# UNITED STATES PATENT AND TRADEMARK OFFICE

APPLICATION NO.	FILING DATE	FIRST NAMED INVENTOR	ATTORNEY DOCKET NO.	CONFIRMATION NO.
10/597,472	08/05/2008	Fumito Hirano	90606.613/ym	1659
54071	7590	02/16/2011		
YAMAHA C/O KEATING & BENNETT, LLP 1800 Alexander Bell Drive SUITE 200 Reston, VA 20191			EXAMINER SCHARICH, MARC A	
			ART UNIT 3611	PAPER NUMBER
			NOTIFICATION DATE 02/16/2011	DELIVERY MODE ELECTRONIC

<b>Office Action Summary</b>	<b>Application No.</b> 10/597,472	<b>Applicant(s)</b> HIRANO ET AL.	
	<b>Examiner</b> MARC A. SCHARICH	<b>Art Unit</b> 3611

Fig. 1

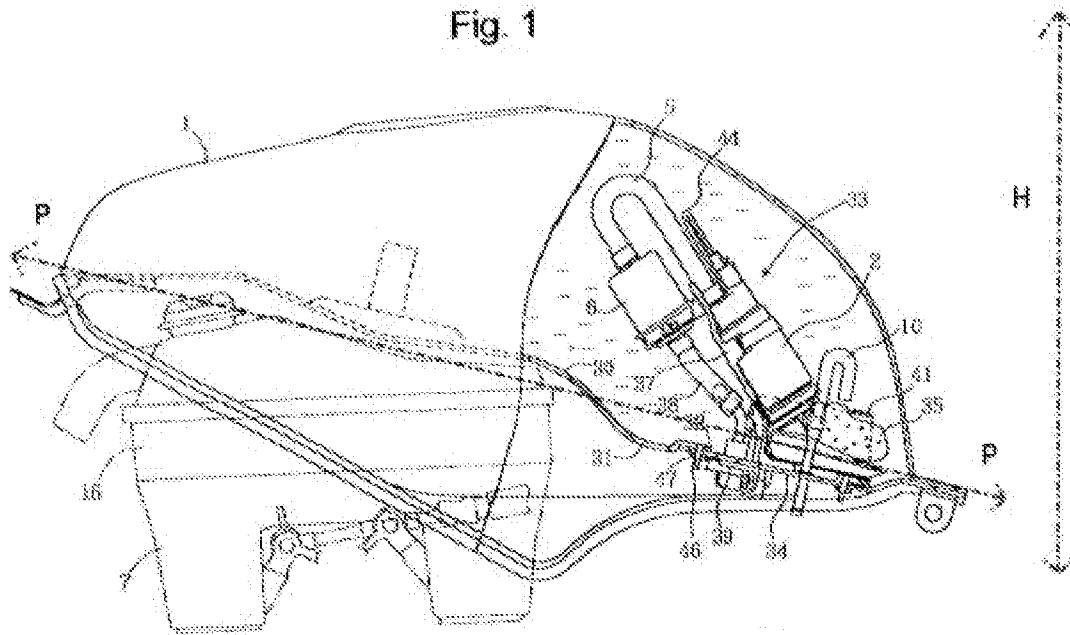
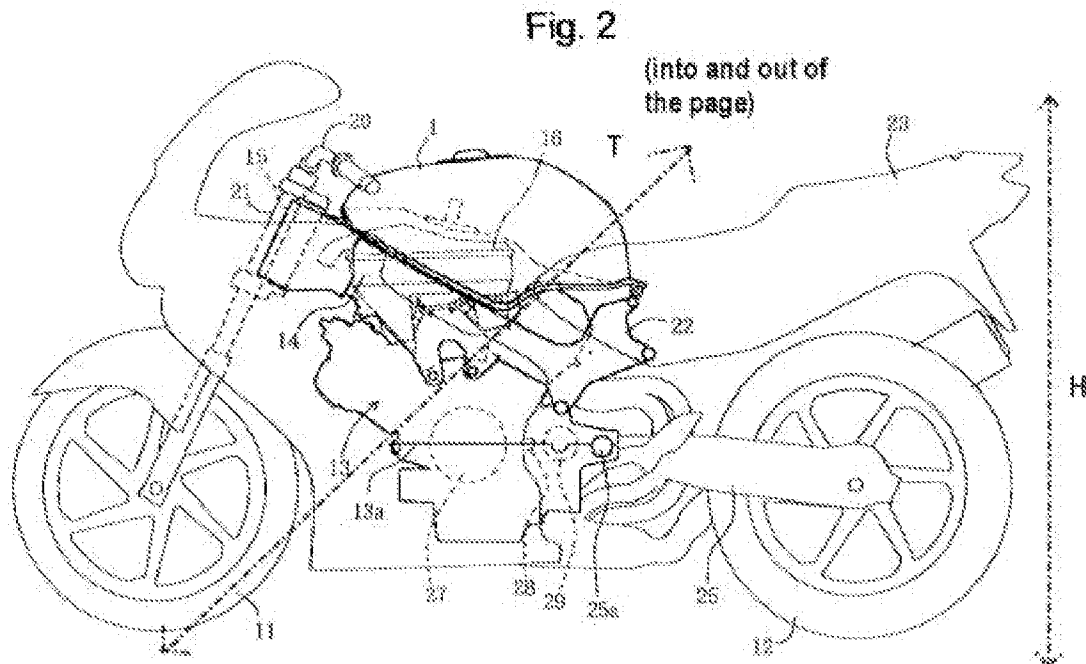
**Claims 11-16, 18, 19 and 21-25** are rejected under 35 U.S.C. 102(b) as being anticipated by Nakashima et al., U.S. Patent No. 6,182,640.

Nakashima et al. discloses a straddle type vehicle [*motorcycle*] (Fig. 2) comprising *at least* a frame assembly [*main frame*] (14), a fuel tank (1) straddling

[*extending overtop and covering*] the frame assembly (14) in a transverse [*side-to-side*] direction (T) [*extending into and out of the page*] relative to a vertical height direction (H) of the vehicle [*see included Figs. 1 and 2 below*], a fuel pump assembly (33) extending into/inside the fuel tank (1) (Fig. 1), the fuel tank (1) comprising a generally horizontal [*flat*] rear surface portion [*part*] (31) formed on a bottom (30) of the fuel tank (1) (Fig. 1) {also see Col. 3, Lines 29-33}, and the fuel pump assembly (33) being mounted to the generally horizontal rear surface portion (31) with a “pump axis” (P) [*see included Figs. 1 and 2 below*] of a strainer (4) (Fig. 3) of the fuel pump assembly (33) extending “generally horizontally”; wherein the frame assembly (14) comprises a frame component [*main frame structure*] that extends at an angle downward and rearward (Fig. 2) such that a rear portion of the frame component [*main frame structure*] is lower than a forward portion of the frame component [*main frame structure*] (see Fig. 2), and the fuel pump assembly (33) is positioned in a rearward portion of the fuel tank (1) (Fig. 1); wherein the fuel pump assembly (33) is positioned in the fuel tank (1) with the “generally horizontally” extending pump axis (P) [*see included Figs. 1 and 2 below*] of the fuel pump assembly (33) also extending “generally transverse” relative to the height direction (H) of the vehicle; and wherein the fuel tank (1) comprises a pump attaching opening (32) defined in at least the generally horizontal rear surface portion (31) and a size of the pump attaching opening (32) is minimized while permitting insertion of the fuel pump assembly (33) into the fuel tank (1) (Fig. 1); wherein the pump attaching opening (32) comprises an elongated configuration [*the opening (32) is covered by a corresponding generally elongated/circular-shaped base plate (34), which is discussed*

*below*]; wherein the fuel pump assembly (33) comprises a generally elongated/circular-shaped attaching portion [*base plate*] (34) (Fig. 5) and the attaching portion (34) is sized slightly larger than the pump attaching opening (32) such that the attaching portion (34) can close and seal off the pump attaching opening (32) (Fig. 1); and wherein the fuel pump assembly (33) further comprises a fuel pump (2) and the attaching portion [*base plate*] (34) is positioned under [*projected underneath*] only a portion [*approx 7/8*] of the fuel pump (2) (Fig. 3).

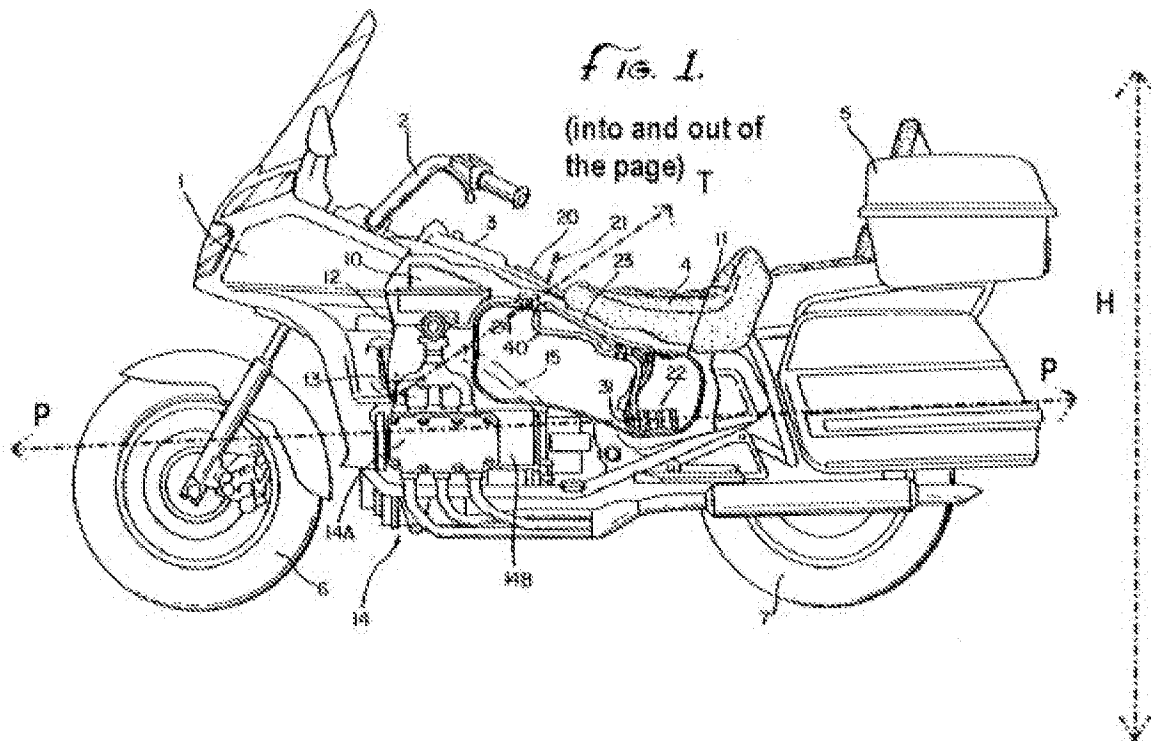
**Claims 11-14 and 18-21** are rejected under 35 U.S.C. 102(b) as being anticipated by Saito et al., U.S. Patent No. 4,871,041.

Saito et al. discloses a straddle type vehicle [*motorcycle*] (Fig. 1) comprising at least a frame assembly [*overall vehicle body*] (unnumbered) which further comprises at least a frame component [*frame element*] (15) [*further described below*], a fuel tank (11) straddling the frame assembly in a transverse [*side-to-side*] direction (T) [*extending into and out of the page*] relative to a vertical height direction (H) of the straddle type vehicle [*see included Fig. 1 below*], a fuel pump assembly [*pump unit*] (22) extending within the fuel tank (11) (Figs. 1 and 2), the fuel tank (11) comprising a generally horizontal [*flat*] rear surface portion formed on a bottom of the fuel tank (11) (Fig. 2), and the fuel pump assembly (22) being mounted to the generally horizontal rear surface portion [*at (31b)*]

(Fig. 2) and having a central “pump axis” (P) [*see included Fig. 1 below*] of the fuel pump assembly (22) extending “generally horizontally”; wherein the fuel tank (11) further comprises an opening [*supply port*] (16) which appears to be capable of receiving the fuel pump assembly (22) therethrough due to the fuel pump assembly (22) being cylindrically shaped and apparently small enough to enter inside of the fuel tank (11) (Fig. 4); wherein the opening (16) of the fuel tank (11) further comprises an “elongated configuration” [*mating cap (17) for covering the supply port (16) contains an elongated handle*] (Fig. 3); wherein the frame component (15) of the frame assembly extends at an angle downward and rearward (Fig. 1) such that a rear portion of the frame component (15) is lower than a forward portion of the frame component (15) (Fig. 1), and the fuel pump assembly (22) is positioned in a rearward portion of the fuel tank (11) (Fig. 2); wherein the fuel tank (11) comprises a recessed forward portion [*bifurcated shape*], the frame component (15) of the frame assembly extending centrally alongside [*within*] the recessed forward portion such that the fuel tank (11) straddles the frame component (15) (Fig. 1) {also see Col. 3, Lines 11-14}, and the fuel pump assembly (22) is positioned rearward of the recessed forward portion of the fuel tank (11) [*the pump unit (22) is positioned well behind where frame element (15) is straddled by the fuel tank (11)*] (Fig. 1); and wherein the fuel pump assembly (22) is positioned in the fuel tank (11) with the “generally horizontally” extending pump axis (P) [*see included Fig. 1*] of the fuel pump assembly (22) also extending “generally transverse” relative to the height direction (H) of the straddle type vehicle.
